**STAFF REPORT:** APRIL 10, 2024, SPECIAL MEETING

**APPLICATION NUMBER:** HDC2024-00144

**ADDRESS:** 1942 GRAND RIVER

**SCOPE:** INSTALL WALL SIGNS AND AWNINGS

*Sketches of proposed aluminum canopies (left) and fabric awnings (right). Images from application documents.*

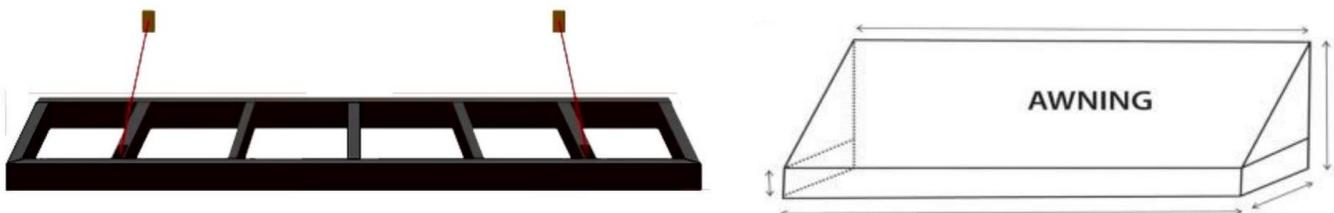
- The proposed canopy and awning locations appear to be consistent with the above guidelines, though clarity is needed on the location and mounting of the Grand River canopy location (see Issues, below).
- The primary (southwest-facing, Grand River) entrance to the building is extremely important to the building's character. Staff suggests that the relatively shallow degree of projection (3.5 feet), dark color, and the fact that it is not illuminated or signed would give the canopy a subdued appearance that does not distract from this important feature. Its placement avoids interrupting or damaging the carved stone capitals and wood spandrel panels that are a distinctive feature of that opening.

- It is unclear how the proposed sign will be mounted. Anchors and electrical penetrations should drill into mortar joints rather than stone.
- The mounting location of the proposed Grand River canopy is not clearly depicted in the application materials. The proposed canopy is stated to be 12' in width and 8' from the ground, which would correspond to the location shown in the image below (an appropriate location, in the opinion of staff). Further, the canopy must be mounted in a manner that does not damage historic materials.
- The proposed canopy would bisect the glass in the flanking windows, creating an atypical, awkward, and ahistorical condition (see image below).

- Anchors and penetrations shall be placed in mortar joints rather than stone.
- Awning and canopy locations and anchor points will be subject to review by staff to ensure they do not obscure or damage historic materials.
- The Grand River canopy will be reduced to twelve feet in width to avoid covering the adjacent windows.
